Public Service of New Hampshire

NEW HAMPSHIRE YANKEE DIVISION

Subject: NRC Requests for Additional Information

In discussions with our Bethesda Licensing Office, various members of the Staff requested additional information/clarifications concerning a few items. In response to these questions, enclosed please find the following attachments:

NSG-SK-0001

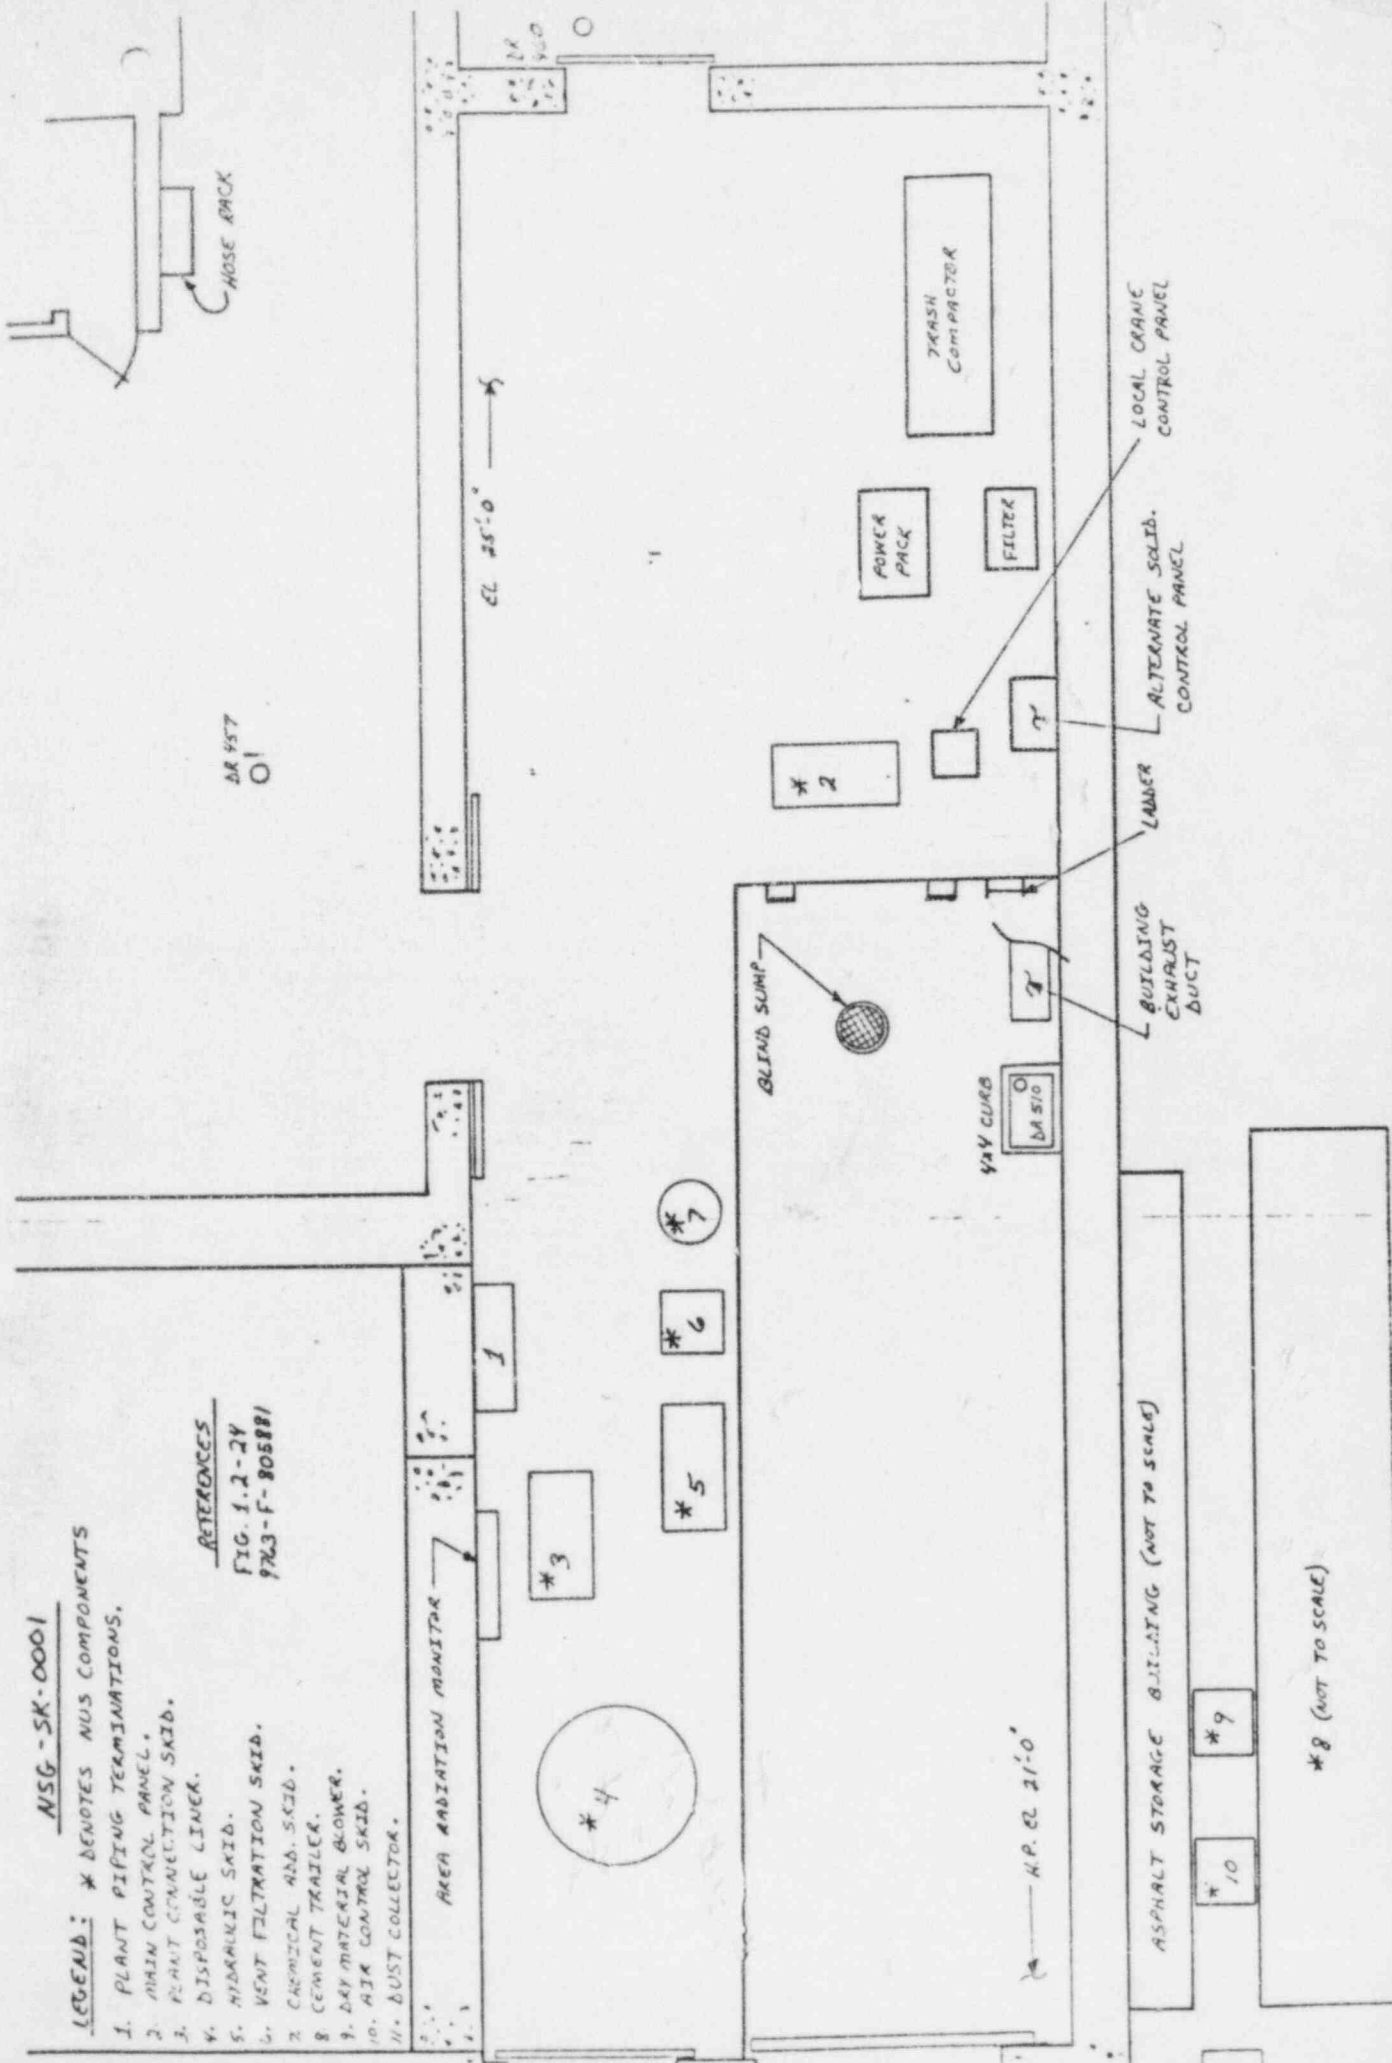
The attached sketch, NSG-SK-0001 illustrates a typical equipment arrangement but does not constitute the final arrangement. Final equipment arrangements must consider plant conditions at the time of processing and require final approval by the Station Radwaste/Utilities Supervisor and the NUS Project Manager. Processing activities must also comply with station issued radiation work permits.

Final equipment arrangements will include the following considerations.

- I. Radioactive components will be segregated from nonradioactive components, to the extent practical. Sufficient space exists in the area to locate temporary shielding, if required.

2. Spill control methods for the final arrangement will be evaluated prior to processing. Such methods may include but are not limited to absorbants and temporary curbing. Local, permanent plant floor drains are available for incorporation into the spill control technique, if required.
3. NUS maintains the disposable liner at a negative pressure with their vent filtration skid which includes a HEPA filter. The discharge of this unit may be routed to a local building ventilation exhaust duct, if required.
